**Beaver Valley Power Station
Unit Nos. 1 and 2**

**License Amendment Requests
302 and 173**

Extended Power Uprate

L-04-125

FIGURE 3.4-1
DOSE EQUIVALENT I-131 Primary Coolant Specific Activity Limit
Versus Percent of RATED THERMAL POWER with the Primary
Coolant Specific Activity > 0.400,35 $\mu\text{Ci/gram}$ DOSE EQUIVALENT I-131

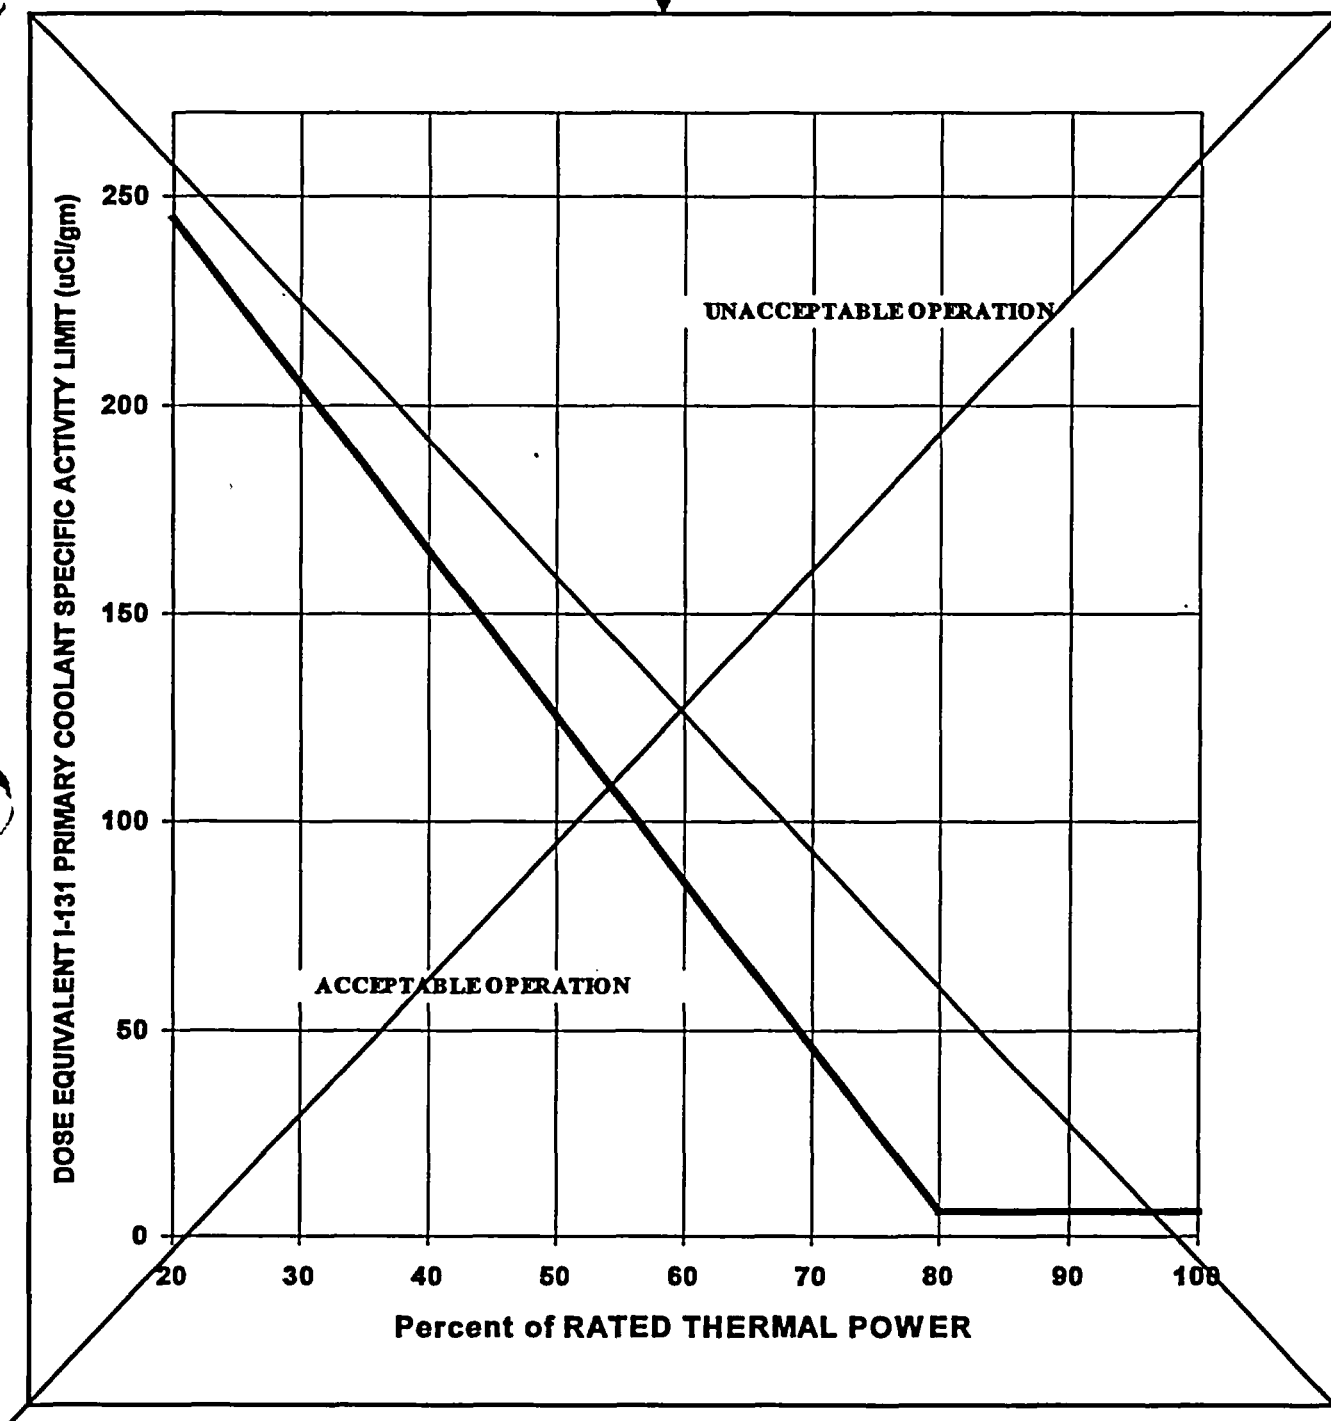
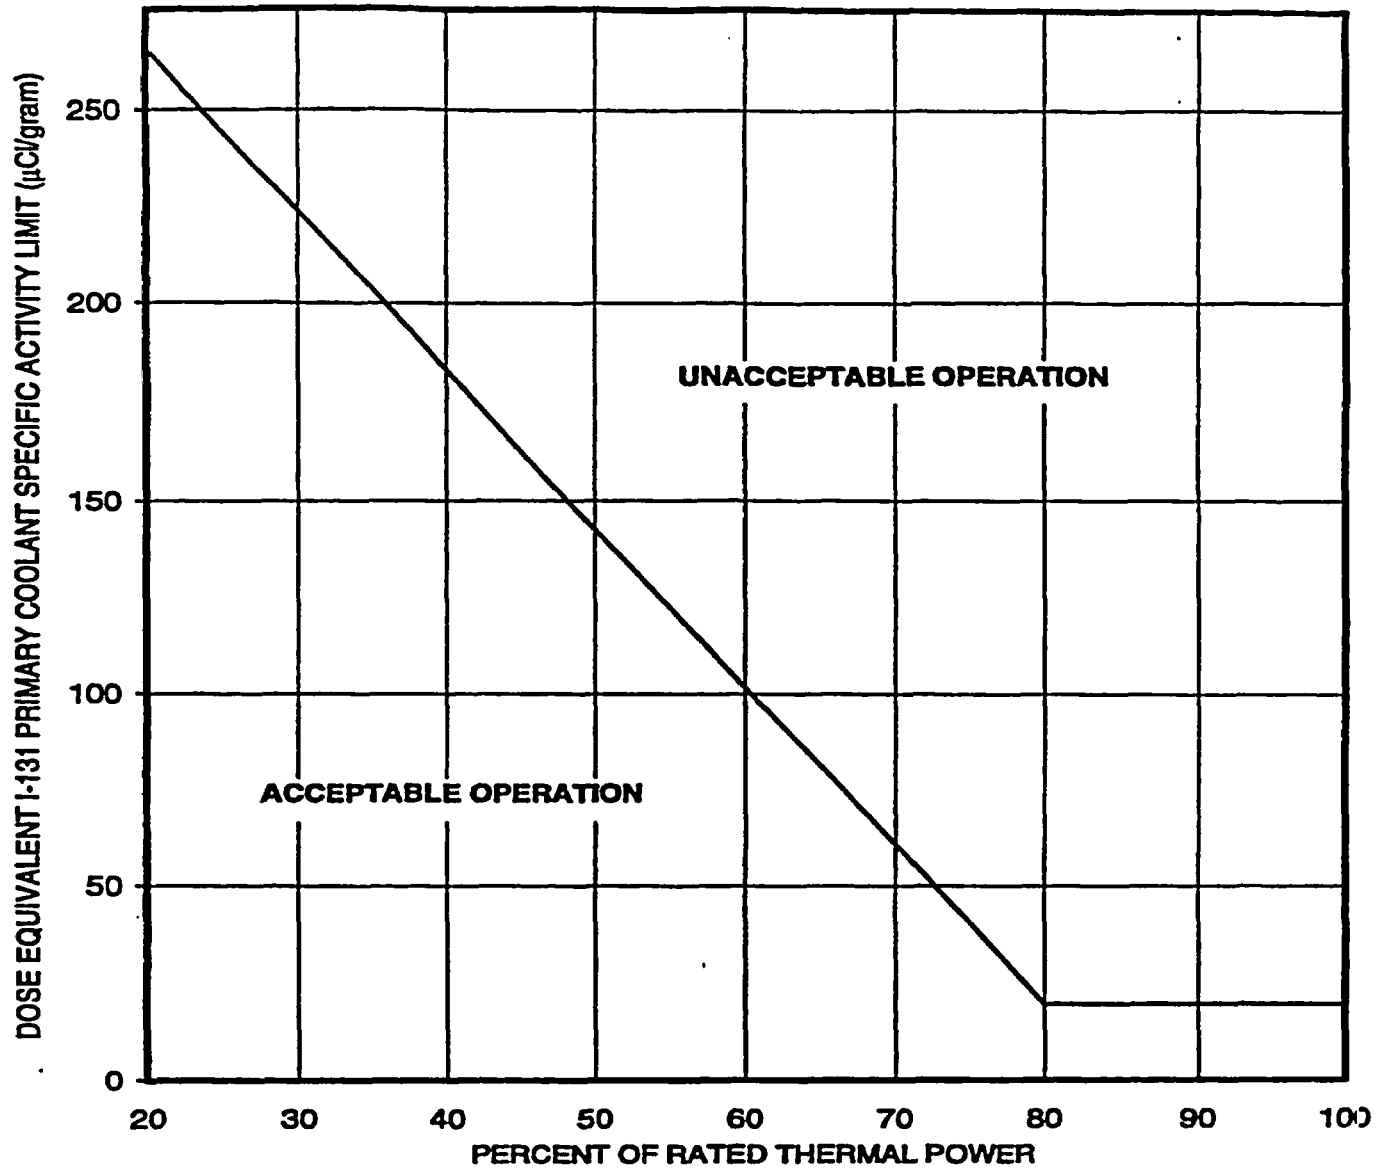
- a. With the specific activity of the primary coolant $> \cancel{0.100.35} \mu\text{Ci/gram DOSE EQUIVALENT I-131}$ ⁽¹⁾ for more than 48 hours during one continuous time interval or exceeding the limit line shown on Figure 3.4-1, be in HOT STANDBY with $T_{\text{avg}} < 500^\circ\text{F}$ within 6 hours.
- b. With the specific activity of the primary coolant $> 100/\bar{E} \mu\text{Ci/gram}$, be in HOT STANDBY with $T_{\text{avg}} < 500^\circ\text{F}$ within 6 hours.

Replace with Insert A1-1.

Insert A1-1.

Figure 4.1-5
REACTOR CORE SAFETY LIMIT
THREE LOOP OPERATION
(Technical Specification Safety Limit 2.1.1)

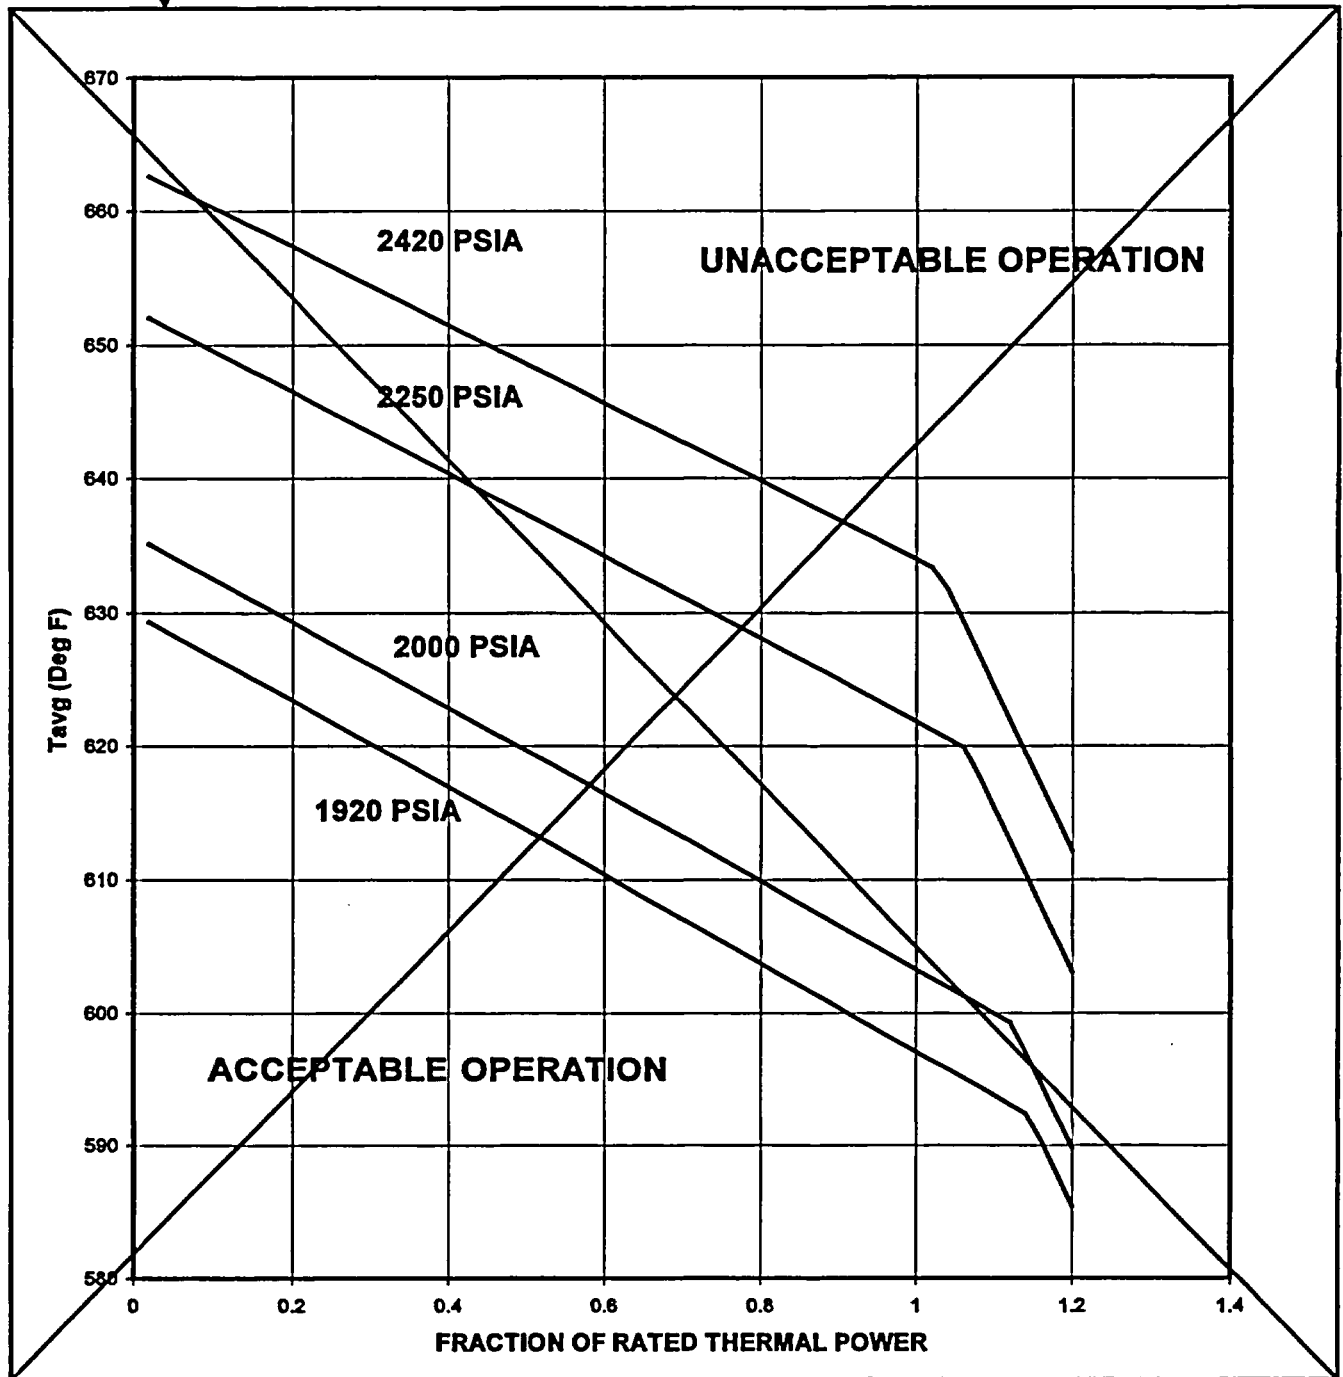
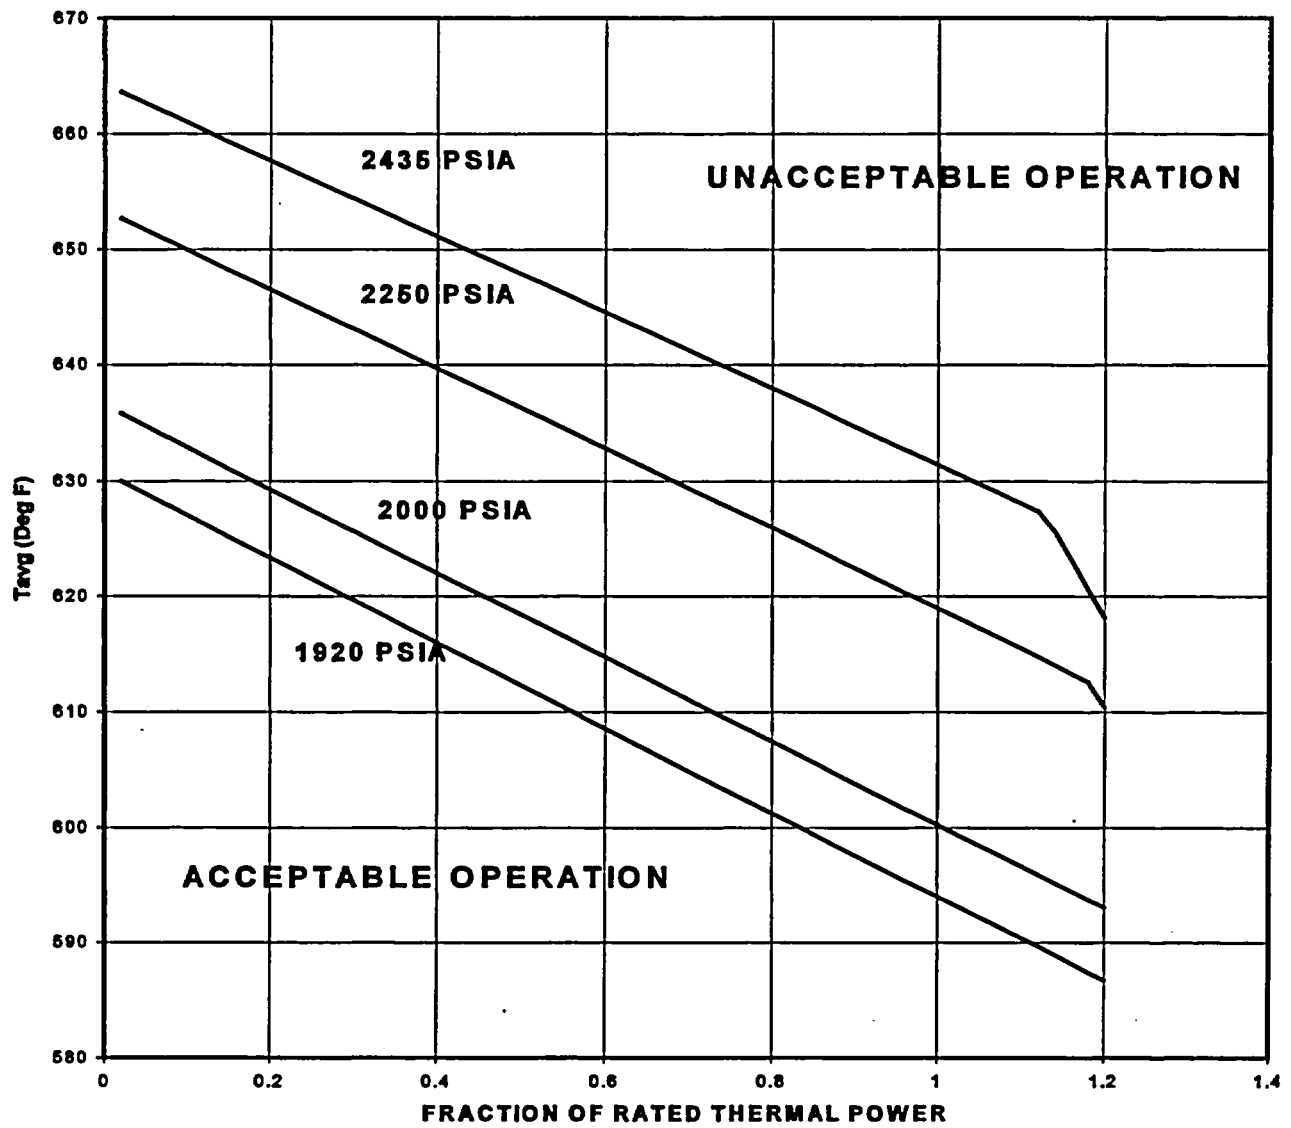
- (d) changing the reference power levels in the leading edge flow meter licensing requirement;
- (e) modifying the reactor core safety limit figure;
- (f) adding a reference to Westinghouse letter FENOC-02-304 to the Bases of TS 3.4.5;
- (g) revising the TS Bases for TS 3.7.1.2, Auxiliary Feedwater System, and TS 3.7.7, Control Room Habitability System;
- (h) revising the Effective Full Power Years for the reactor coolant system heatup and cooldown curves for Unit 1 only; and
- (i) revising the TS Bases and LRM to reflect the full implementation of the AST methodology.

Insert C1-3.

Figure 4.2-1
Reactor Coolant System Heatup
Limitations Applicable for the First 22-21 EFPY (TS 3.4.9.1)

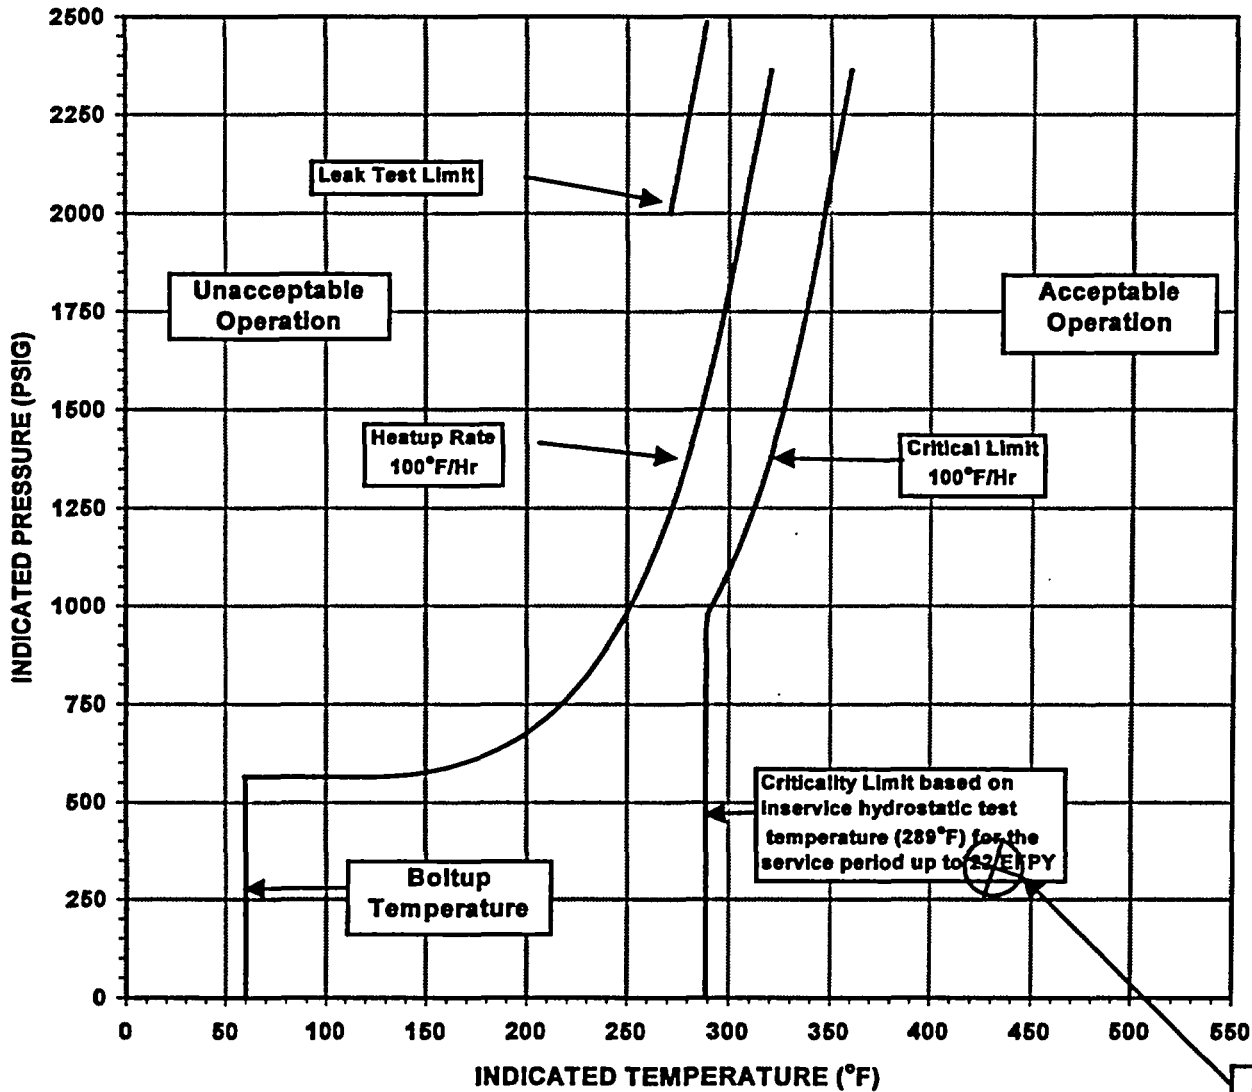
1/4T, 233°F

3/4T, 196°F

Figure 4.2-1
 Reactor Coolant System Heatup
 Limitations Applicable for the First 1422 EFPY (TS 3.4.9.1)

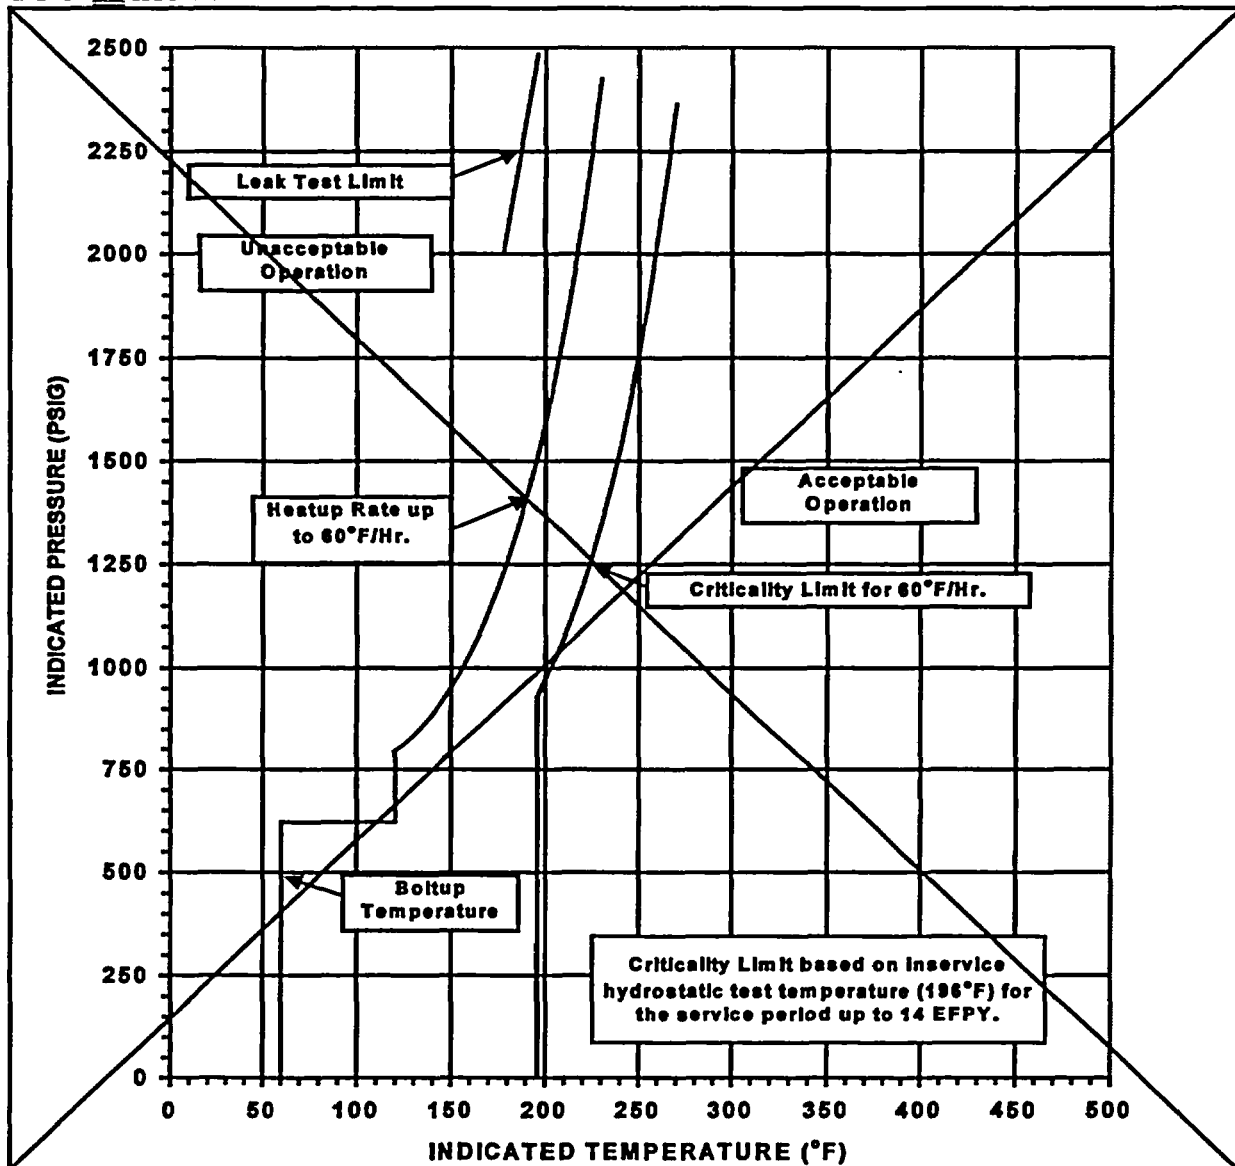
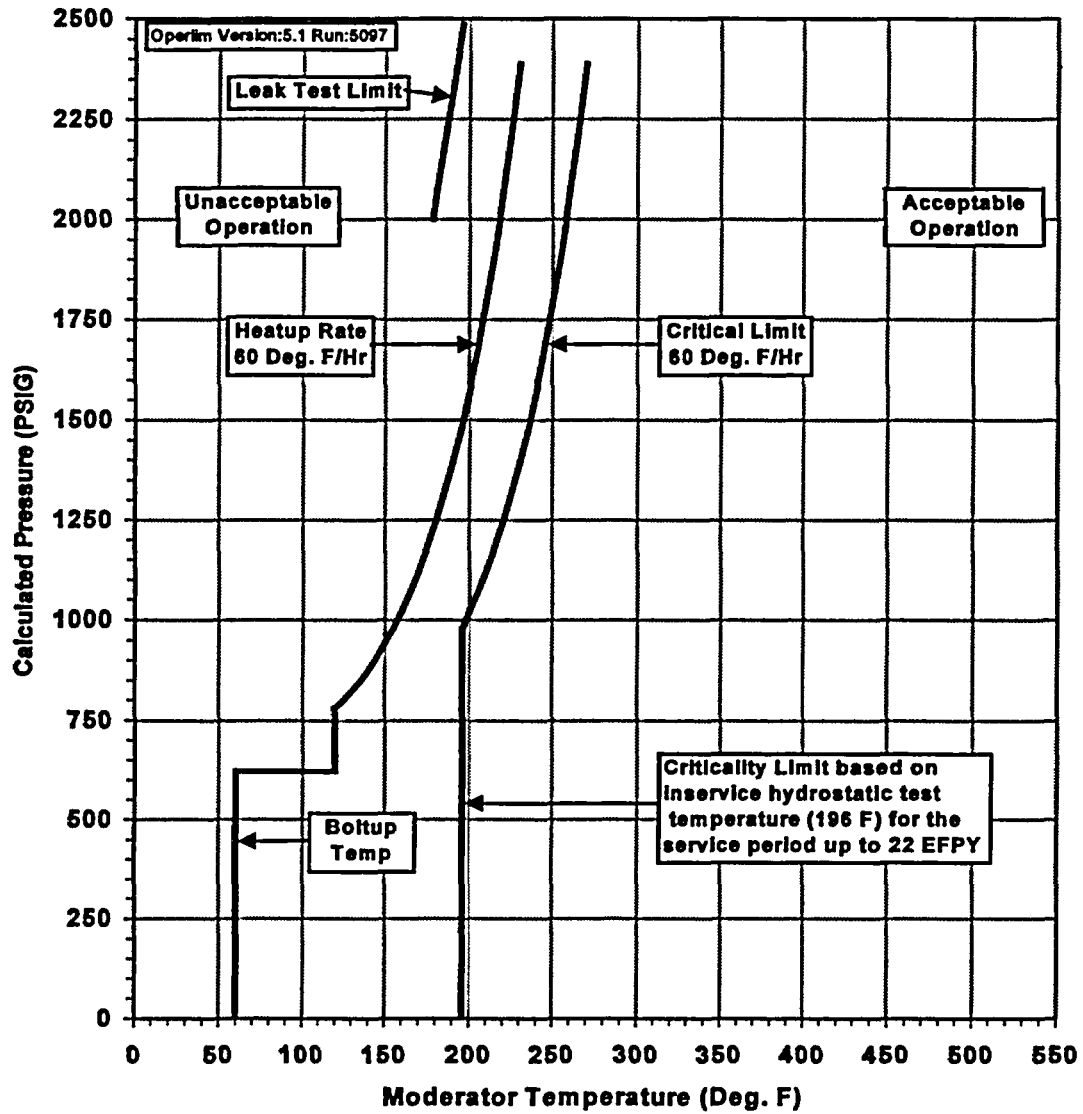
CONTROLLING MATERIAL: INTERMEDIATE SHELL PLATE B9004-1
 INITIAL RT_{NDT}: 60°F
 RT_{NDT} AFTER 1422 EFPY: 1/4T, 140°F
 3/4T, 128, 129°F

Replace with
 Insert C2-4.

Insert C2-4.
